Re: Appeal of Alamo Manhattan Blocks in South Waterfront  
LU 20-102914 DZM GW AD; PC # 19-22572

1. Graduating building heights from the western boundary to the waterfront. This view of the RiverPlace community, in the foreground, was captured from the east side of the Willamette River and shows how the Central City buildings step down in height toward the Willamette River.

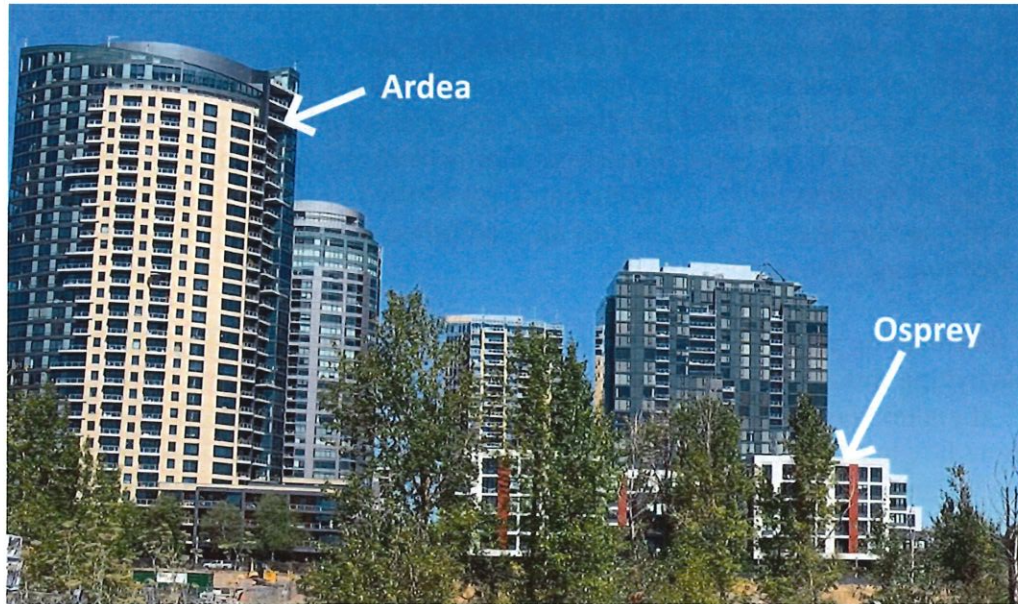
Buildings are to step down in height from the next, to the next as the built environment moves closer to the river. The Guidelines illustrates this concept as follows:

By using this stepped-down gradation in building heights, the Design Guidelines ensure that the visual and physical connection to the water – the singular distinguishing feature of the South Waterfront – is maximized. It is this openness and vast visual access to the river (as well as the sky) that makes the South Waterfront a desirable place to live. A good example of this gradation

exists directly to the north of the subject property where The Osprey townhouses, a five-story structure abuts the river and The Ardea, a multi-story tower, sits further behind.

Rather than following this established pattern, this applicant elected to turn this obligation on its head. Instead of graduating its development down toward the river, it elected to graduate the building heights upward as the buildings move closer to the river. Massive, 250' towers abut the river on Blocks 41 and 44 blocking the shorter mid-rise 74' buildings on Blocks 42 and 45 behind. This is the opposite of the pattern created to the north. These mid-rise buildings contain the affordable housing units – depriving those on the interior blocks of any visual access to the river. This is not what Design Guideline D2 and, as discussed in greater detail below, Guideline C1 require.
